ONSITE SEWAGE DISPOSAL SYSTEM

PROPERTY ADDRESS: 10605 Reynolds Court

SUBDIVISION: Kingsley Woods

From: Silvast, Zackary <zsilvast@howardcountymd.gov>
Sent: Monday, September 11, 2023 1:51 PM
To: Ryan Ketner; Michael Boyce; Greg Simons
Cc: Wolf, Kevin; Page, Shepsura; Bernard, Dana; Matthew Geckle
Subject: regarding BAT site plan for "LOT 13 - King's Forest"
Attachments: Lot 13 King's Forest - New Spec Sheet.pdf

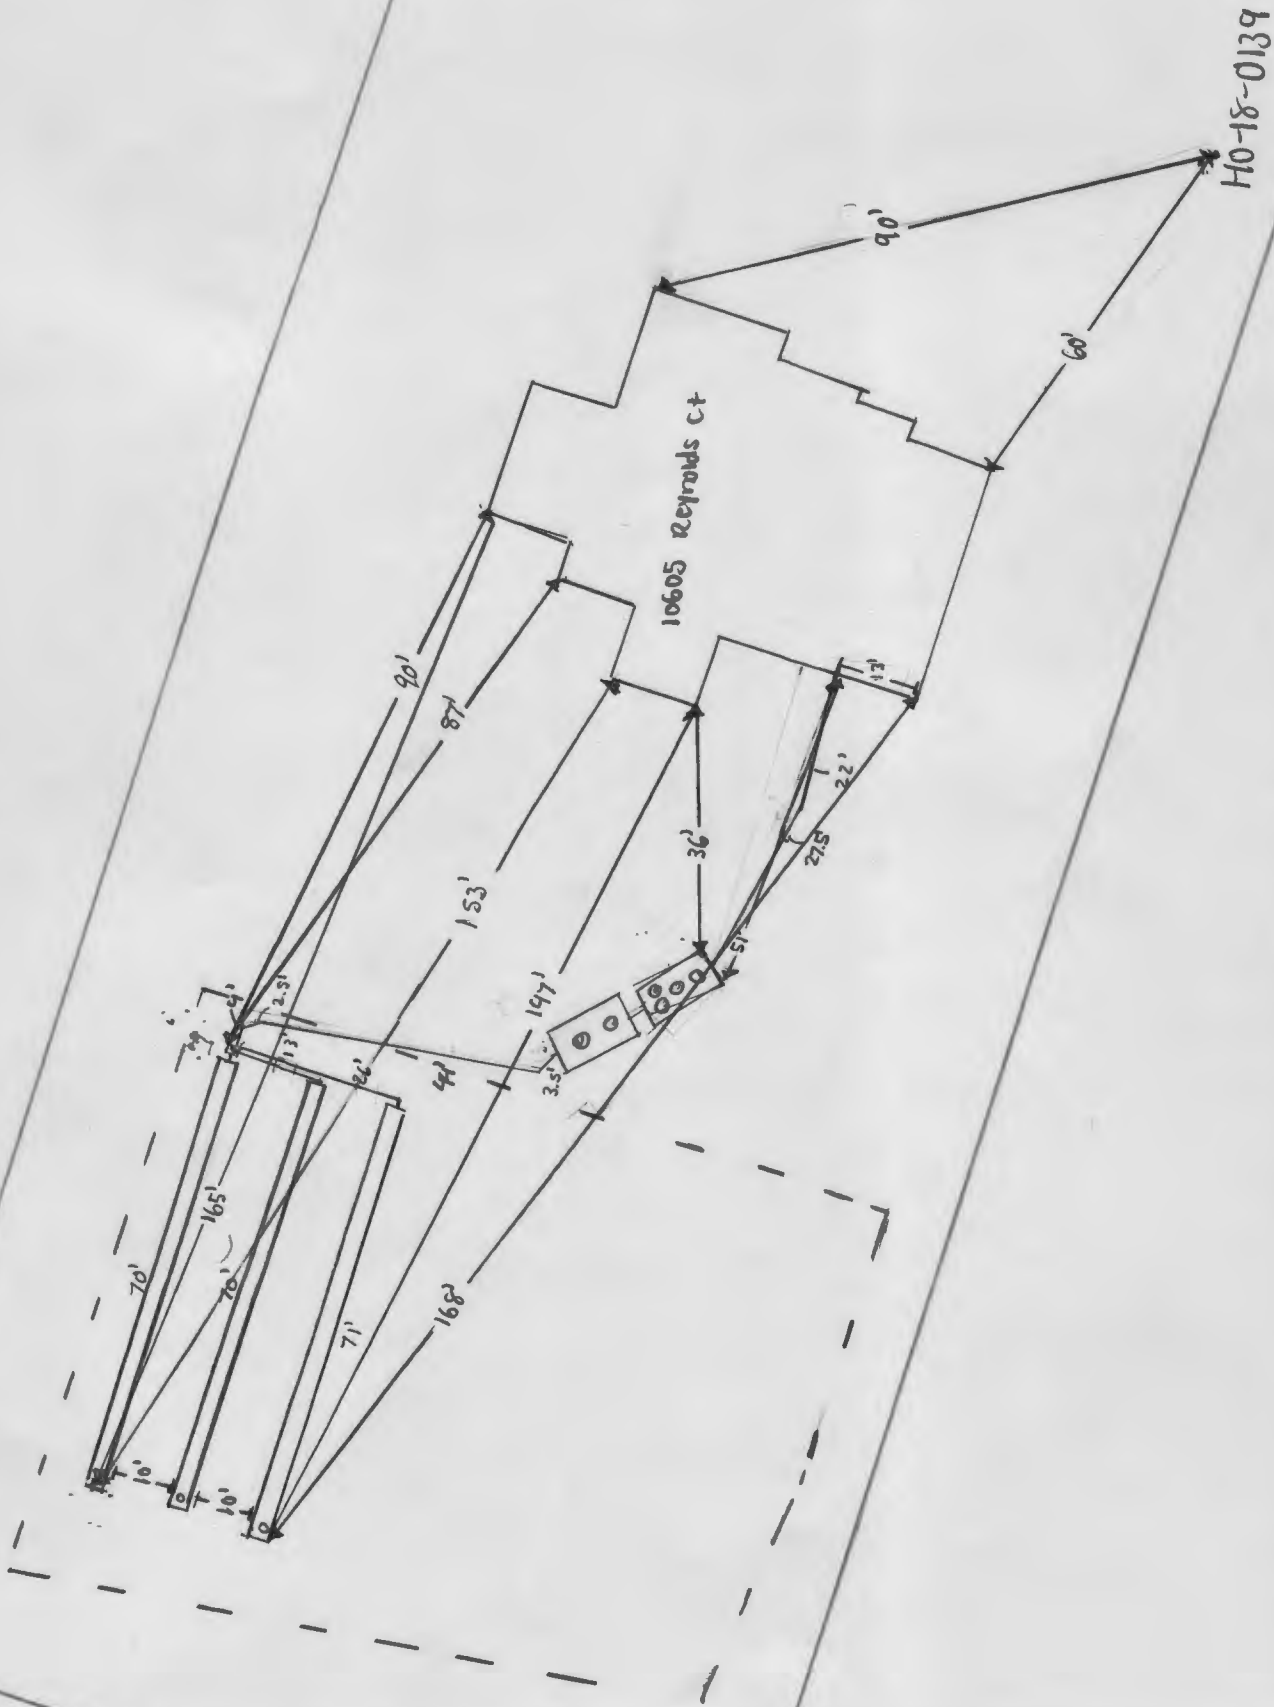
9/5/2023 - Installer onsite pre-con. SDA not staked, do not start work.

9/8/2023 - SDA staked, trench staked, tanks staked. MCH = 100' from tank & SDA.

Upper trench @ 99' & elevation difference 1". Lower trench @ 93' & elevation difference 1" - 1.5". Lower trench @ 93' & elevation difference 1" - 3". Upper trench on SDA line & lower trench moved down 3' to accommodate 10' between trenches. 10/4/23 - laid out trenches according to new plan - 3x70' stakes in place for ST's & dbbox confirmed a 750 Norweco will be used, contractor stated that he'll only install one clo in the sewer line near the house, the plan calls for 2, ok + start. (2)

10/16/2023 - line from foundation to inlet installed, adequate fall, clo near foundation & J-box

No PVC used. septic tank installed & pump tank installed, less than 3' of cover on tank. Request for PMT trench (2)

10/11/2023 - PM 280 PSI. D-box installed w/ port. trenches installed length 2x 70', 70', & 11'.

Inlet @ 2'-2.5'. ok to backfill all work. Needs P & A (2) 10/30/23 - Pump & Alarm ok.

WASP panel installed in the side of house w/ the 3 circ. & breakers in the panel (pump, alarm & monitor) - (2)
